SUBJECT: ISSUANCE OF AMENDMENT - JOSEPH M. FARLEY NUCLEAR PLANT,  
UNIT 1 (TAC NO. M98268)

AMENDMENT TO FACILITY OPERATING LICENSE

Amendment No.128  
License No. NPF-2

SAFETY EVALUATION BY THE OFFICE OF NUCLEAR REACTOR REGULATION  
RELATED TO AMENDMENT NO. 128 TO FACILITY OPERATING LICENSE NO. NPF-2

FIGURE 3.4-1

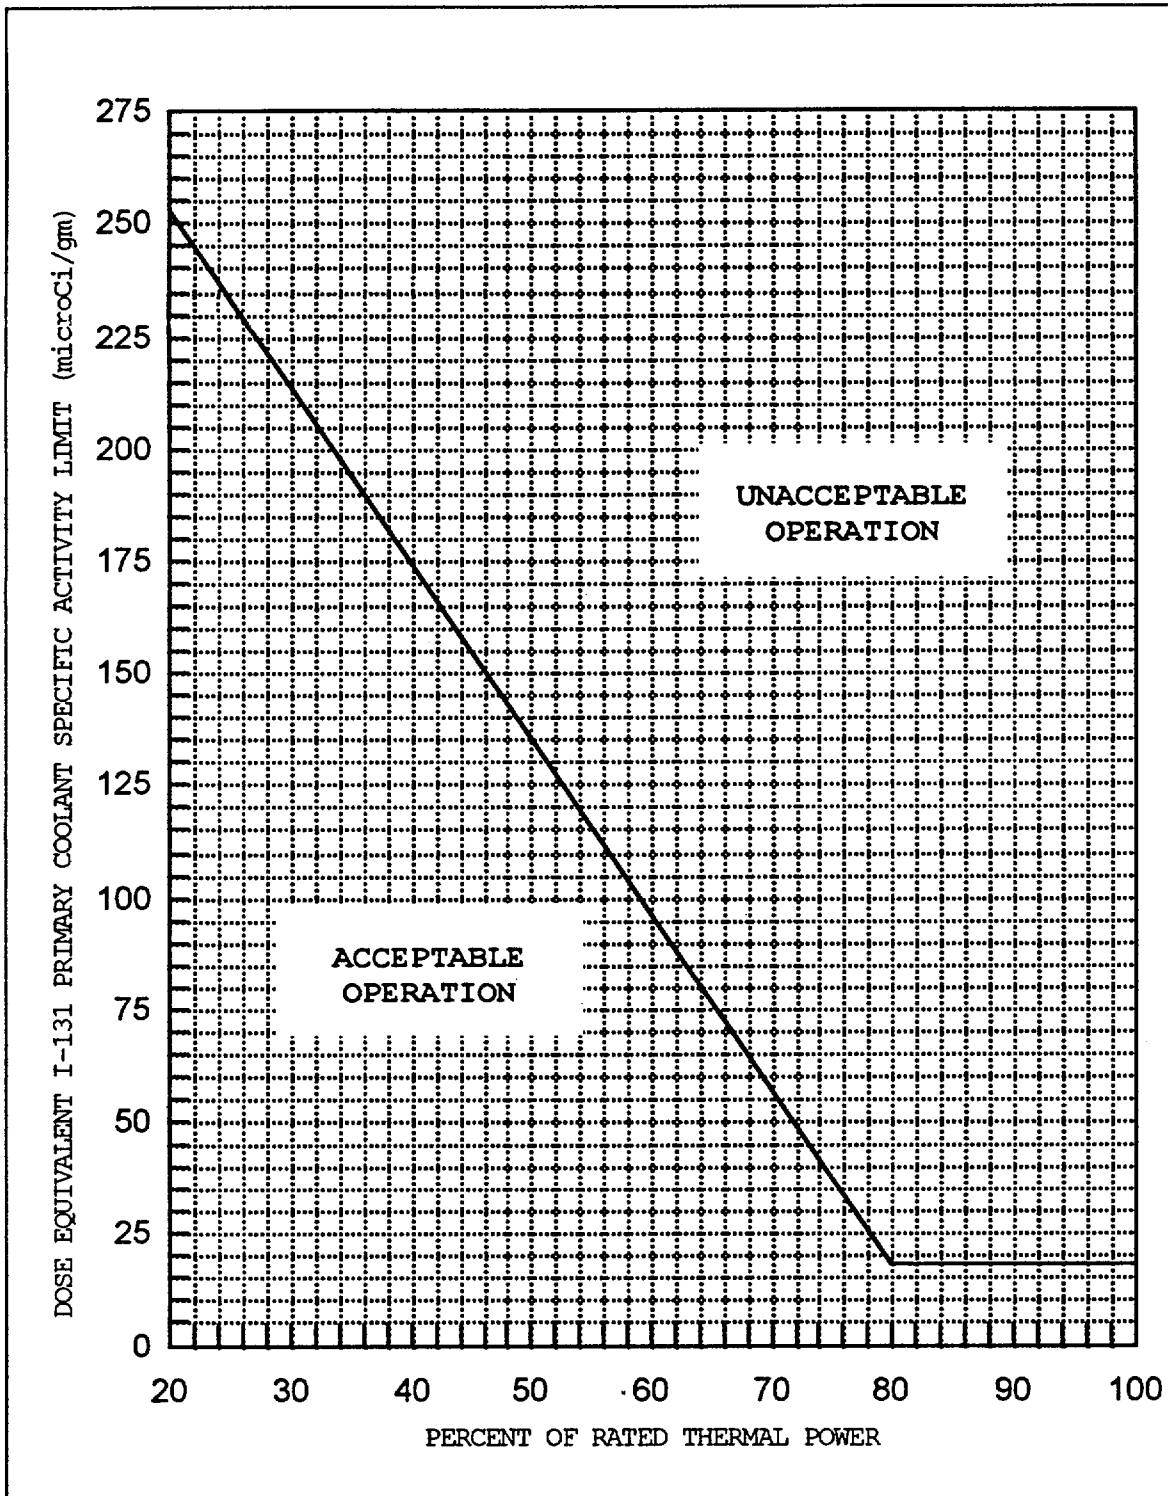
- a. With the specific activity of the primary coolant greater than 0.3 microCurie per gram DOSE EQUIVALENT I-131 for more than 48 hours during one continuous time interval or exceeding the limit line shown on Figure 3.4-1, be in at least HOT STANDBY with  $T_{avg}$  less than 500°F within 6 hours.
- b. With the specific activity of the primary coolant greater than  $100/\bar{E}$  microCurie per gram, be in at least HOT STANDBY with  $T_{avg}$  less than 500°F within 6 hours.

The ACTION statement permitting POWER OPERATION to continue for limited time periods with the primary coolant's specific activity greater than 0.3 microCuries/gram DOSE EQUIVALENT I-131, but within the allowable limit shown on Figure 3.4-1, accommodates possible iodine spiking phenomenon which may occur following changes in THERMAL POWER.

DOSE EQUIVALENT I-131 Primary Coolant Specific Activity Limit Versus Percent of RATED THERMAL POWER with the Primary Coolant Specific Activity > 0.3  $\mu$ Ci/gram Dose Equivalent I-131
